License No. 19-00915-03  
Docket No. 030-04530

This is in reference to Condition 29 of NRC License Number 19-00915-03 and the Decommissioning Plan (DP) and Final Status Survey (FSS) for the low-level radioactive waste burial site in Beltsville, Maryland. Excavation activities at the Beltsville site have revealed that the actual locations of buried materials within the well-defined burial site area were not as deep as assumed when developing the DP and FSS. We have also determined that some of the soil sampling and surveying protocols in the DP and FSS are contradictory or incomplete or do not comply with Multi-Agency Radiation Survey and Site Investigation Manual (MARSSIM) guidance. The enclosed BARC Technical Memo – Final Status Survey Plan Improvements, dated May 2014 (developed for USDA by TPMC – Energy Solutions Services, LLC), describes proposed changes to the site excavation depth, number of soil samples to be analyzed, type of radiation level surveys to be performed, and extent of area to be surveyed. These changes are consistent with MARSSIM guidance and will ensure that we obtain sufficient data for release of the site for unrestricted use.

**BARC Technical Memo**  
**Fi

**Figure BTM-02-1  
Excavation Bottom FSS Design Method**

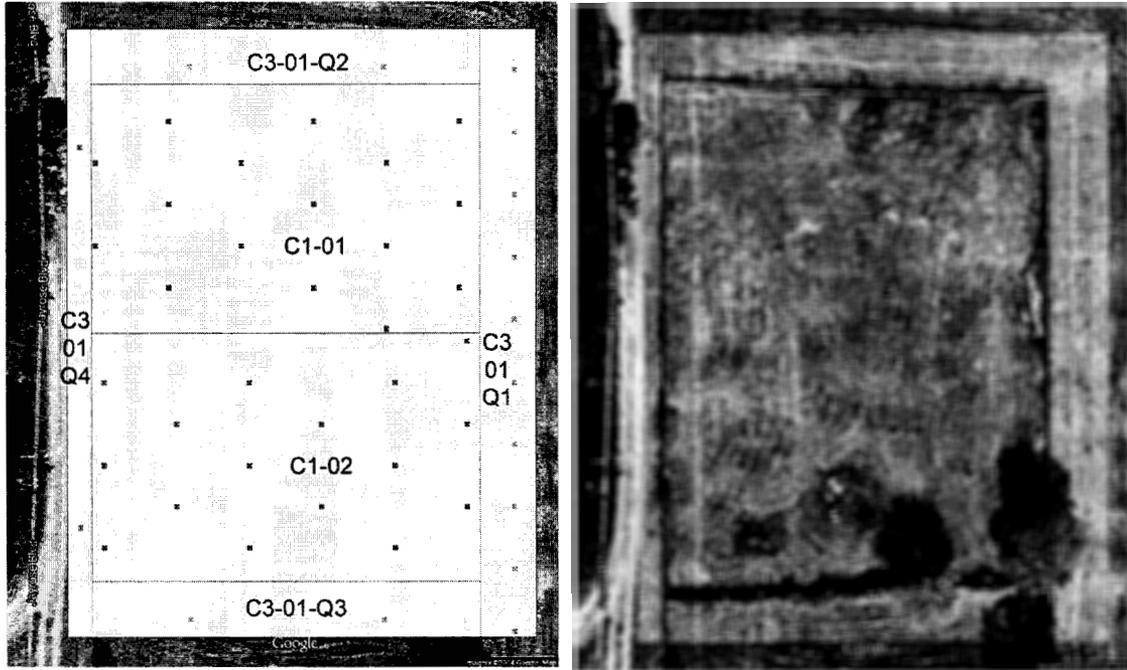
The excavation area will be divided into three survey units, similar to those shown in Figure BTM-02-1, Excavation Bottom FSS Design Method. The portion of the excavation bottom which was previously occupied by the burial site will be divided into two Class 1 survey units, each having an area of approximately 1,455 m<sup>2</sup>. The portion of the excavation bottom surrounding the Class 1 survey units will comprise one Class 3 survey unit with an area of approximately 1,395 m<sup>2</sup>.

Figure BTM-02-1 survey units and sample locations are presented to convey an understanding of the survey design with respect to the survey unit layout and the sample distribution pattern with associated grid spacing. The actual survey units and sample locations, while quite similar to those illustrated, will be marginally different since they will be generated using the final GPS coordinates of the entire excavation, which will not be acquired until excavation activities are complete.

Sixteen (16) systematic samples will be collected from each survey unit. Systematic sample locations will be established using a triangular grid pattern with a random start point. The samples in the Class 3 survey unit will be biased towards the downslope (eastern) portion of the survey unit. This will be accomplished by dividing the survey unit into the four quadrants shown in Figure BTM-02-1, then distributing the samples as shown in the Table BTM-02-1 below:

4. The survey design described in Section 3.5 of this document, consisting of two Class 1 survey units surrounded by one Class 3 survey unit, should be adopted for the final status survey of the excavation bottom.
